Planning & Zoning Board Regular Meeting

August 1, 2023 @ 6:00 pm

4. **Public Hearings**
(Public participation and comment on these matters must be in-person.)
 - a. [SPR #23-09. Request of Max Eliscu.](#) 10 minutes
Request of Max Eliscu for approval to construct a new, single-story, 748 square-foot cabana and a new, two-story, 1,001 square-foot addition to the existing single-family home located at 802 Georgia Avenue on Lake Osceola, zoned R-1AAA.

- b. [Request of Metro Winter Park, LLC: To amend the Comprehensive Plan Future Land Use designation from Institutional to Medium Density Residential to be consistent with the R-3 zoning of the properties and for Conditional Use approval for a two-story, 58-unit multi-family project on the properties at 821 & 831 W. Swoope Ave. and 800, 810 & 830 W. Webster Ave.](#) 60 minutes

GRADING DRAINAGE AND PAVING

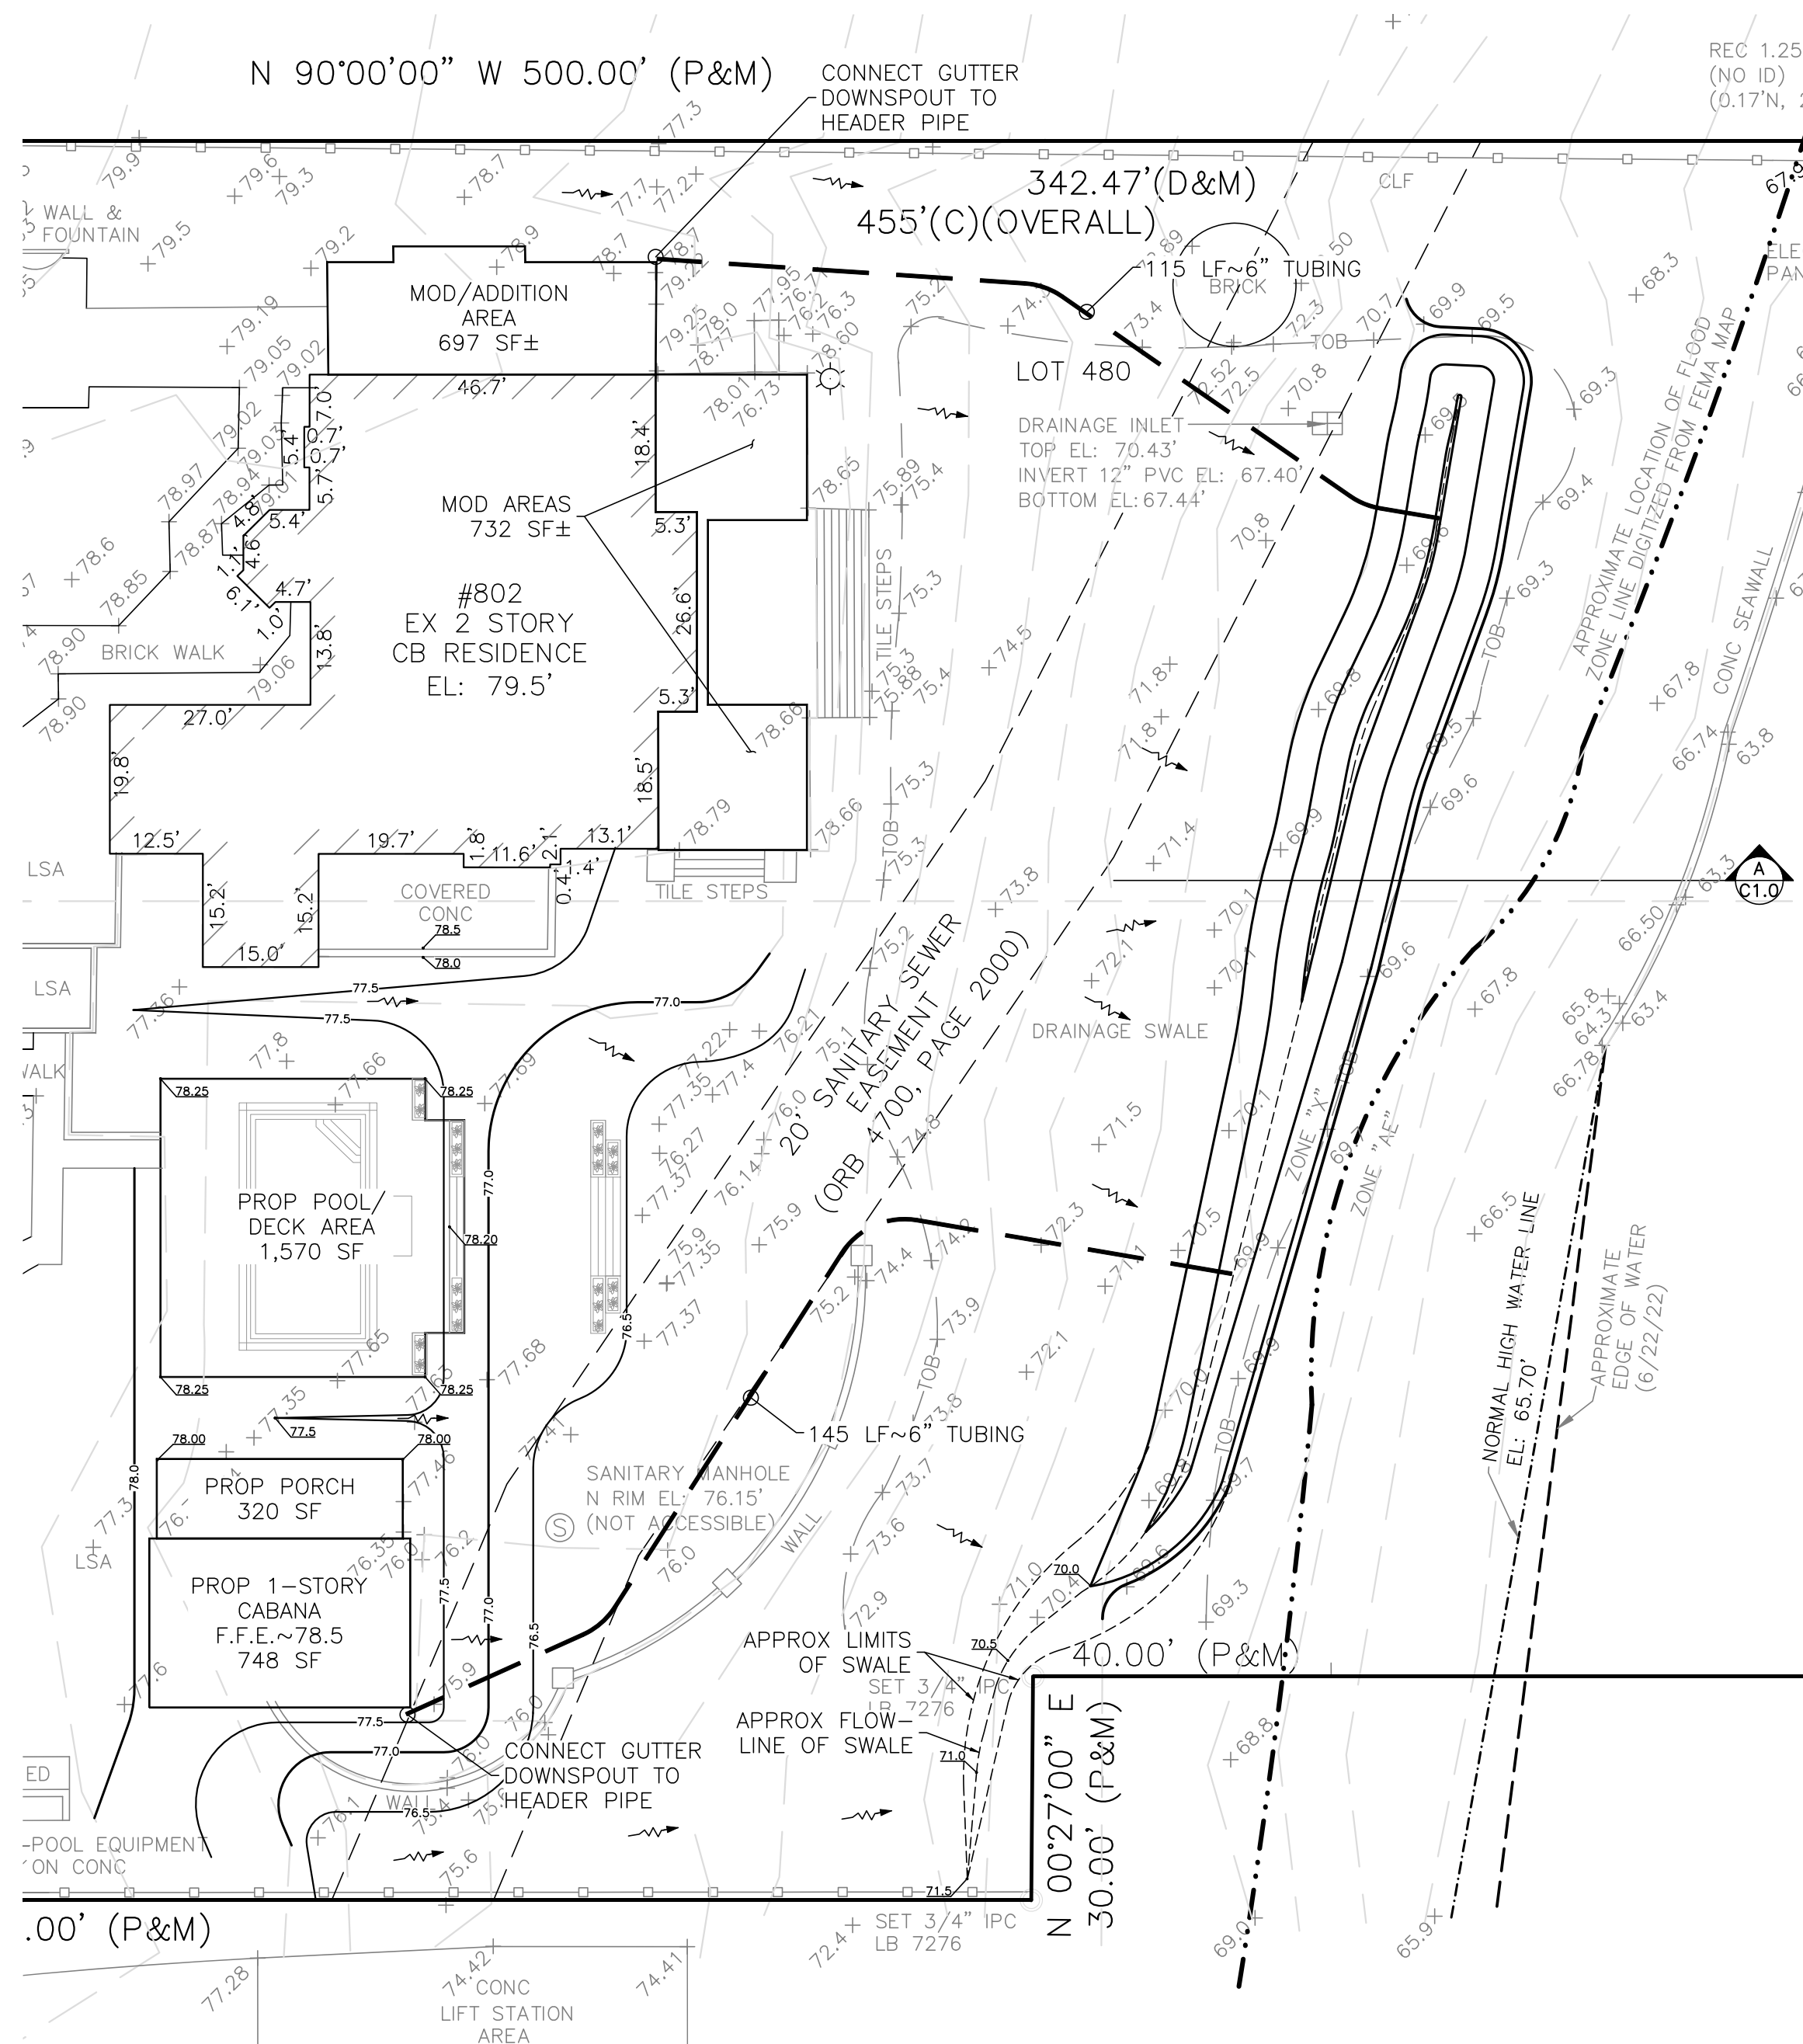
The code direction is to minimize the height and extent of stem walls or retaining walls facing the lake. Generally, the policy does not permit walls/swimming pool decks facing the lake in excess of 3-feet in height. This plan complies with this provision. The proposal includes no wall or deck component greater than 3-feet in height. The existing wall on the property is 2-feet in height also satisfying this requirement.
